July 20, 2007
L-07-084

**Subject: Beaver Valley Power Station, Unit Nos. 1 and 2
BV-1 Docket No. 50-334, License No. DPR-66
BV-2 Docket No. 50-412, License No. NPF-73
Responses to a Request for Additional Information (RAI dated May 21,
2007) in Support of License Amendment Request Nos. 333 and 204 (TAC
Nos. MD2377 MD2378)**

REQUEST FOR ADDITIONAL INFORMATION

REGARDING THE SPENT FUEL POOL CRITICALITY

Figure 1 – Fresh Enrichment vs. k_{eff} for “All-Cell”

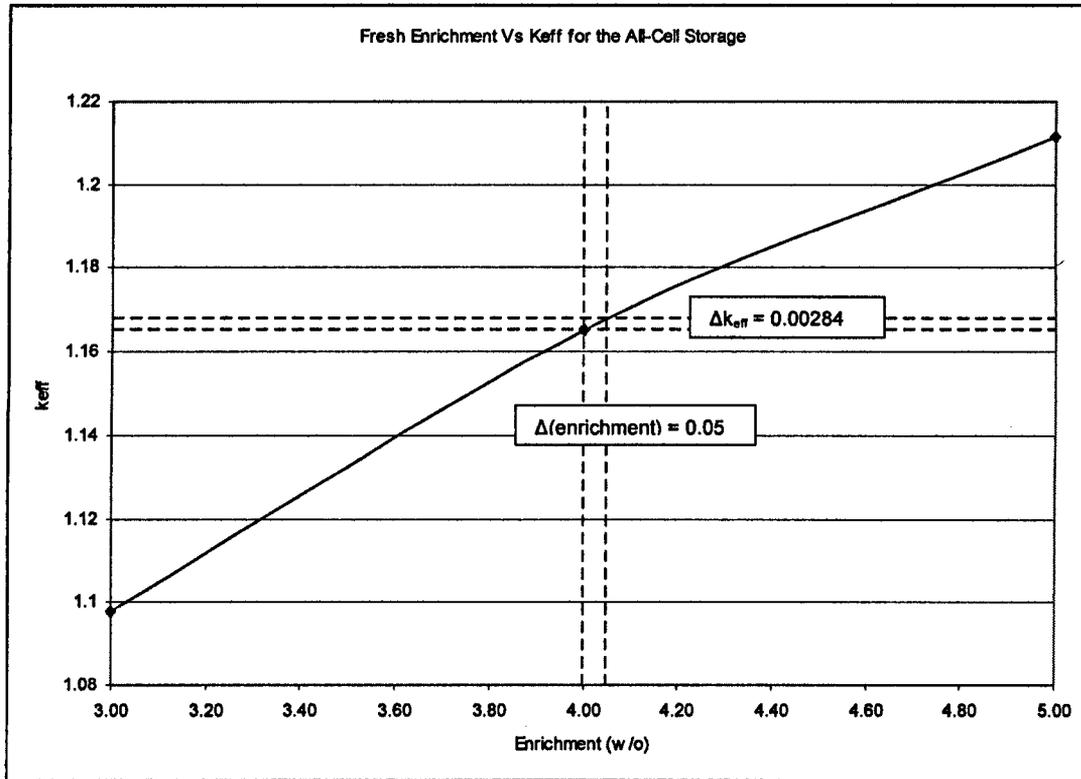
- v. **With respect to the U235 enrichment uncertainty, the footnote does not provide sufficient information to make an assessment of adequacy of the value in the table. Provide a detailed explanation of how the U235 enrichment uncertainty was determined.**

The k_{eff} values were evaluated at 3.0, 4.0, and 5.0 w/o ^{235}U fresh enrichments, and the $\Delta k_{\text{eff}}/\Delta(\text{Enrichment})$ was evaluated at $(4.0 + 0.05)$ w/o ^{235}U using the 2nd order polynomial passing through the 3 data points as shown on Figure 1.

Figure 2 – Burnup vs. k_{eff} at 5.0 w/o ^{235}U for “All-Cell”

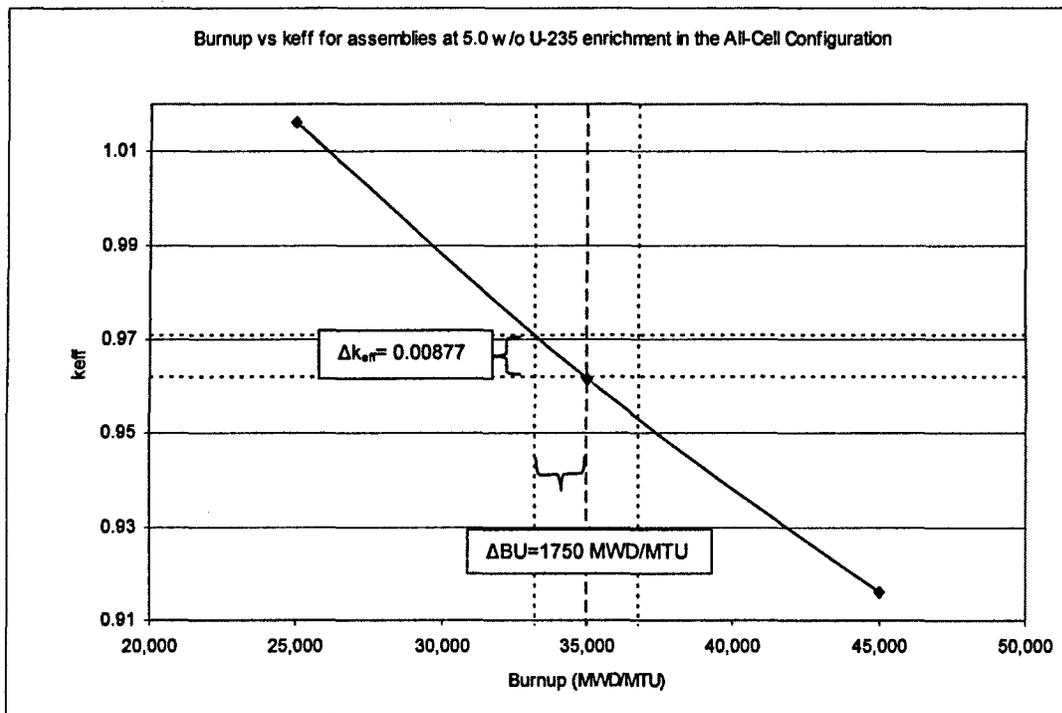
- vi. With respect to the burnup uncertainty, the footnote does not provide sufficient information to make an assessment of adequacy of the value in the table. Provide a detailed explanation of how the burnup uncertainty was determined.

A 5% burnup measurement uncertainty is applied by evaluating the differential burnup worths at the conservative maximum burnup credited value of 35,000 MWD/MTU with 5.0 w/o ^{235}U initial enrichment for the “All-Cell” Configuration. Figure 2 shows the k_{eff} values at the highest burnup limit of 35000 MWD/MTU and 33250 (=35000 – 35000*5%) MWD/MTU and the Δk_{eff} is calculated between these two points. For further explanation please see response to RAI question 19 (a) (vii).

Figure 3 – Burnup vs. k_{eff} for peripheral assemblies in the 3x3 Configuration

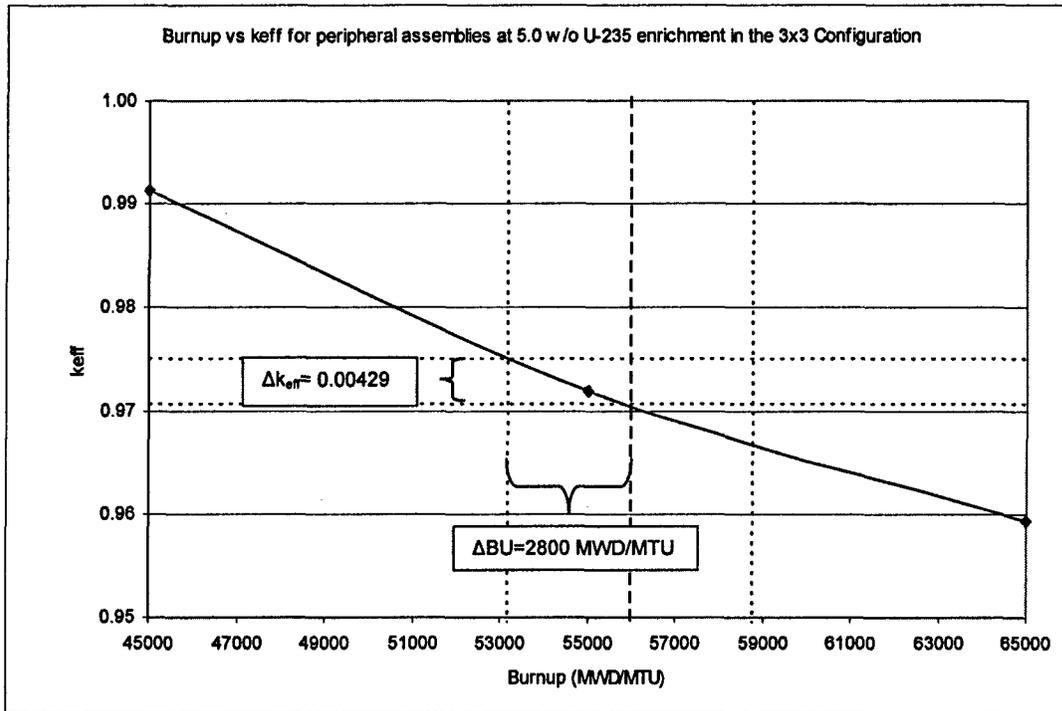
- vi. **With respect to the burnup uncertainty, the footnote does not provide sufficient information to make an assessment of adequacy of the value in the table. Provide a detailed explanation of how the burnup uncertainty was determined.**

A 5% burnup measurement uncertainty is applied by evaluating the differential burnup worths at the conservative maximum burnup credited value of 56,000 MWD/MTU with 5.0 w/o ^{235}U initial enrichment for the peripheral assemblies in the "3x3" configuration. Figure 3 shows the k_{eff} values at the highest burnup limit of 56,000 MWD/MTU and 53,200 (=56,000 - 56,000*5%) MWD/MTU and the Δk_{eff} is calculated between these two points. For further explanation please see response to RAI question 19 (a) (vii).

Figure 4 – Enrichment vs. k_{eff} for 1-out-of-4

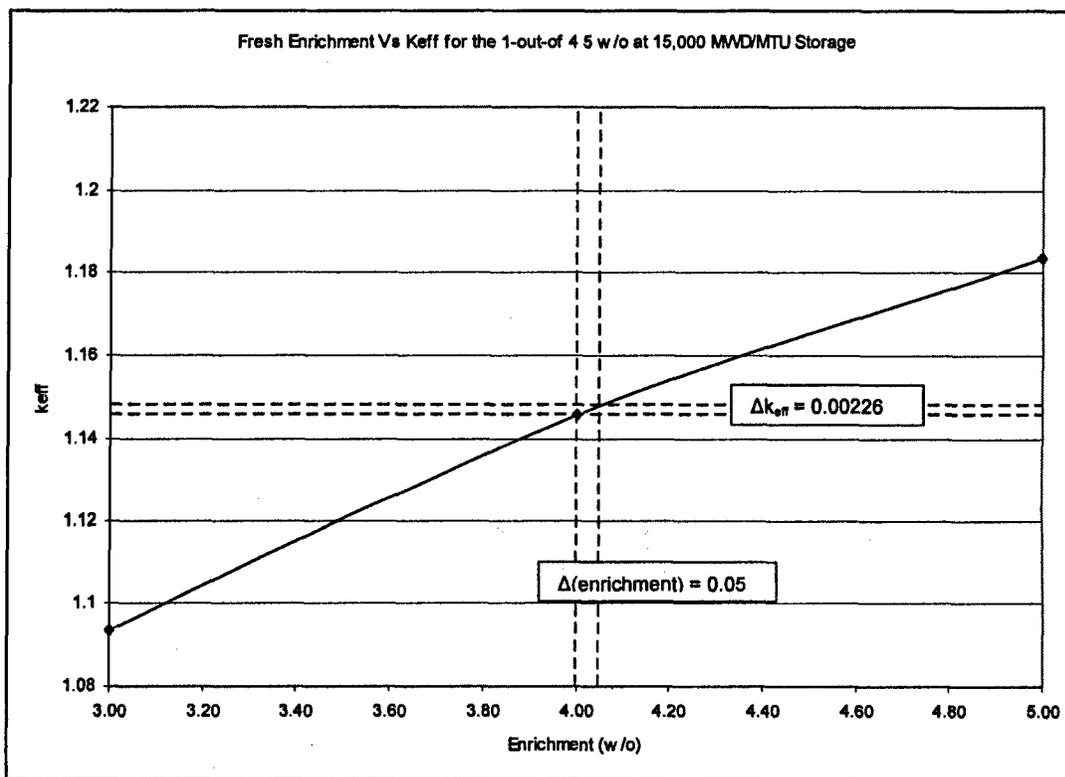
- v. **With respect to the U235 enrichment uncertainty, the footnote does not provide sufficient information to make an assessment of adequacy of the value in the table. Provide a detailed explanation of how the U235 enrichment uncertainty was determined.**

The k_{eff} values were evaluated at 3.0, 4.0, and 5.0 w/o ^{235}U fresh enrichments, and the $\Delta k_{\text{eff}}/\Delta(\text{Enrichment})$ was evaluated at $(4.0 + 0.05)$ w/o ^{235}U using the 2nd order polynomial passing through the 3 data points, while one of the assemblies was kept at 5.0 w/o, 15,000 MWD/MTU. See Figure 4.

Figure 5 – Burnup vs. k_{eff} at 5.0 w/o ^{235}U 1-out-of-4

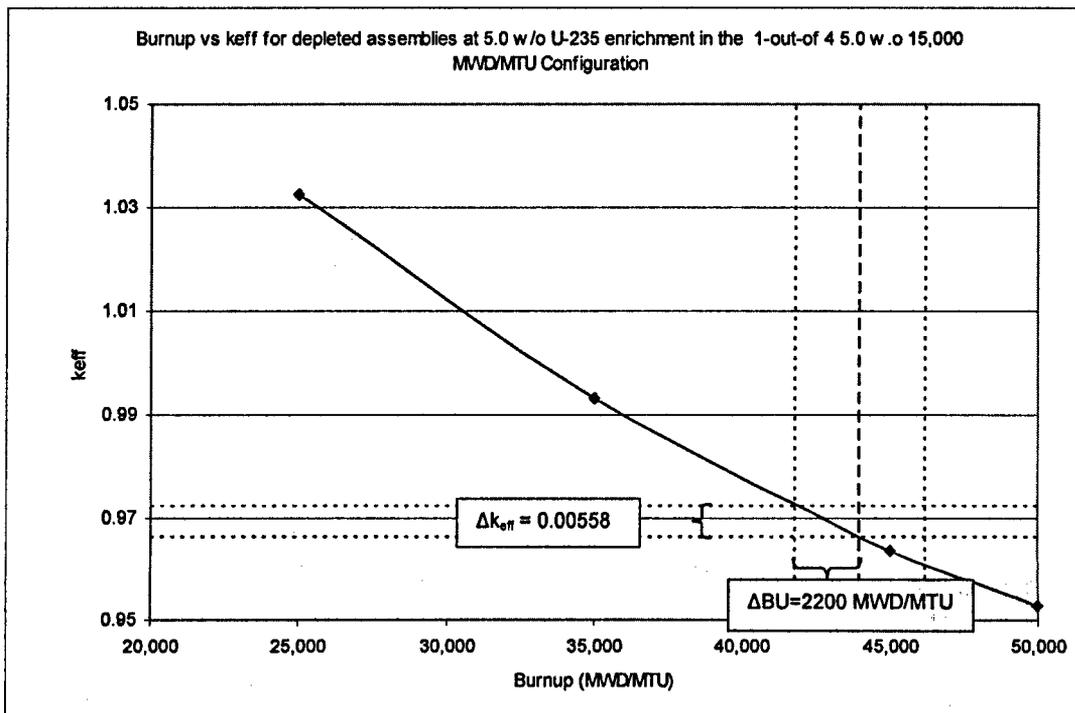
- vi. With respect to the burnup uncertainty, the footnote does not provide sufficient information to make an assessment of adequacy of the value in the table. Provide a detailed explanation of how the burnup uncertainty was determined.

A 5% burnup measurement uncertainty is applied by evaluating the differential burnup worths at the conservative maximum burnup credited value of 44,000 MWD/MTU with 5.0 w/o ^{235}U initial enrichment for the "1-out-of-4 5.0 w/o at 15,000 MWD/MTU" configuration. Using the burnup vs. k_{eff} curve, k_{eff} values at the highest burnup limit of 44000 MWD/MTU and 41800 (=44000 - 44000*5%) MWD/MTU are determined and the Δk_{eff} is calculated between these two points. For further explanation please see response to RAI question 19 (a) (vii).
